## **GOVERNORS WEST ROADWAY IMPROVEMENTS**

**Project No. 65-14-RD12**

### **Addendum #2**

DESCRIPTION: CABELA DRIVE STREET LIGHTS	
DRAWN BY: Julie Brown	AREA PERSON: Richard Knox
CHECKED BY: Richard Knox	OFFICE #: 255-535-1282
CELL PHONE #: N/A	TRUCK #: N/A
WEB #: 81.T-22014.CABELADR	DATE: 10/16/2014
ORDER #:	SCALE: 1" = 100'

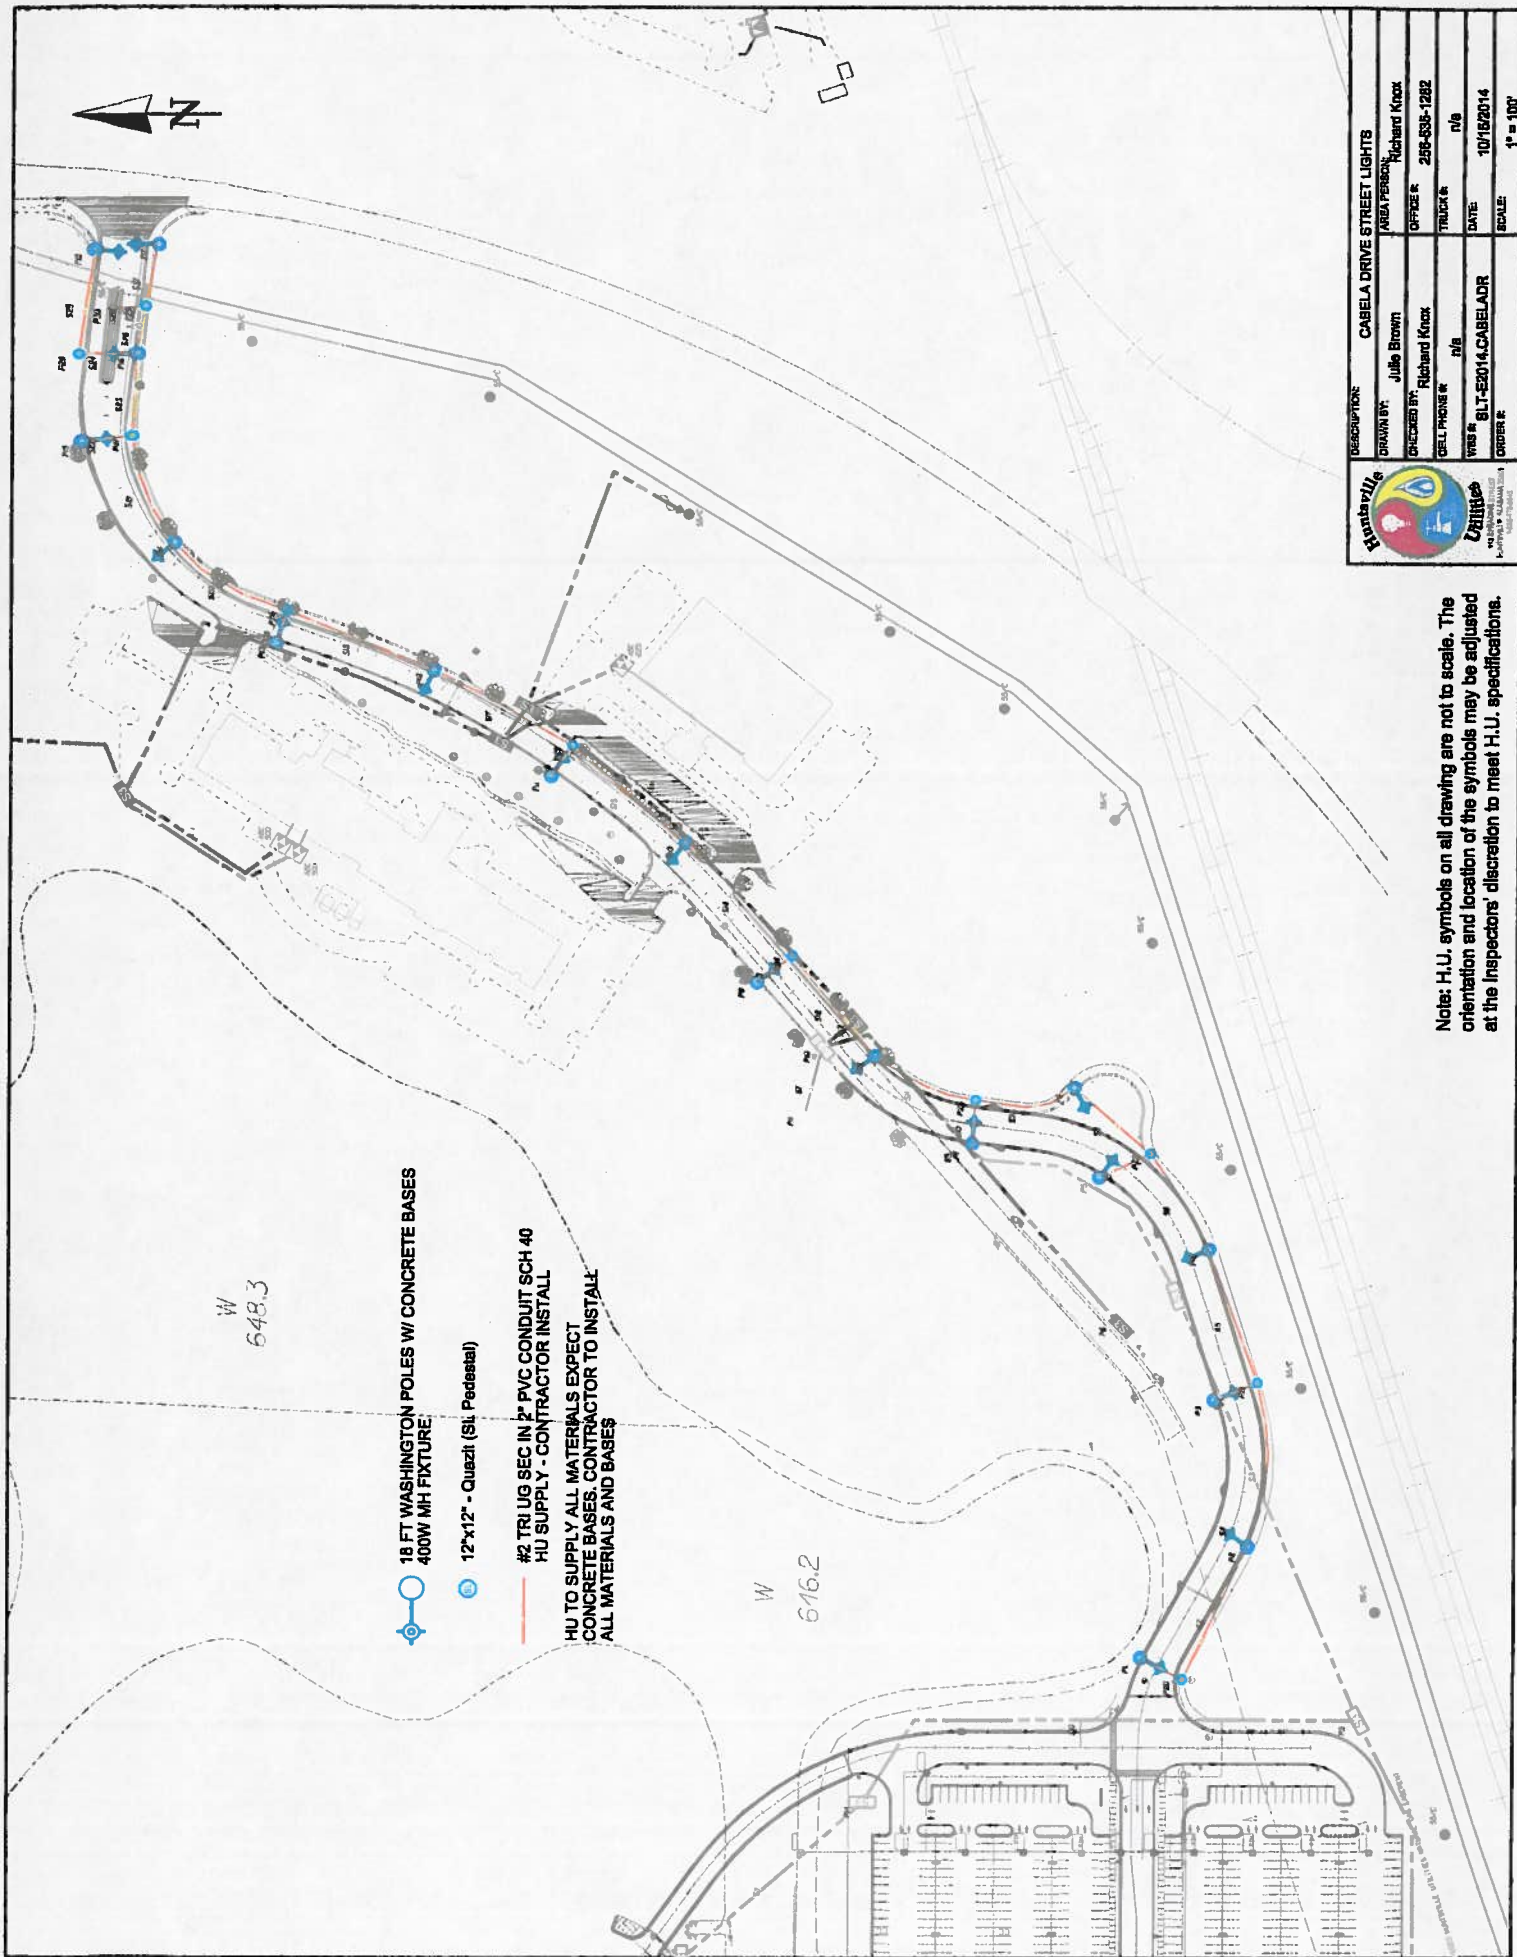
## **2-Option to Extend Existing Lighting Types and Spacing:**

For relocation and extension of existing lighting system, the existing fixtures are 400W Metal Halide fixtures similar to Catalogue No. MPTR-SL-400.ies, 400 Watt Pulse-Start Clear ED-28 Horizontal Burn, 40000 Lumens, 30' Mounting Height, 5' behind curb, these are mounted on 30 foot square poles, with 2' diameter concrete bases. As noted in the bid tab, the contractor will be required to relocate 3 of the existing lights (move light perpendicular to current location, with same offset from the proposed curb line), install 6 new fixtures as per the locations on the Utility Sheets (matching spacing and offsets of existing lights), and provide Huntsville Utilities with 3 additional fixtures. Price shall include all conduit, wiring, and any other materials necessary for complete installation.

18 FT WASHINGTON POLES W/ CONCRETE BASES  
400W MH FIXTURE

#2 TRI LG SEC IN 2" PVC CONDUIT SCH 40  
HU SUPPLY - CONTRACTOR INSTALL

HU TO SUPPLY ALL MATERIALS EXCEPT  
CONCRETE BASES. CONTRACTOR TO INSTALL  
ALL MATERIALS AND BASES
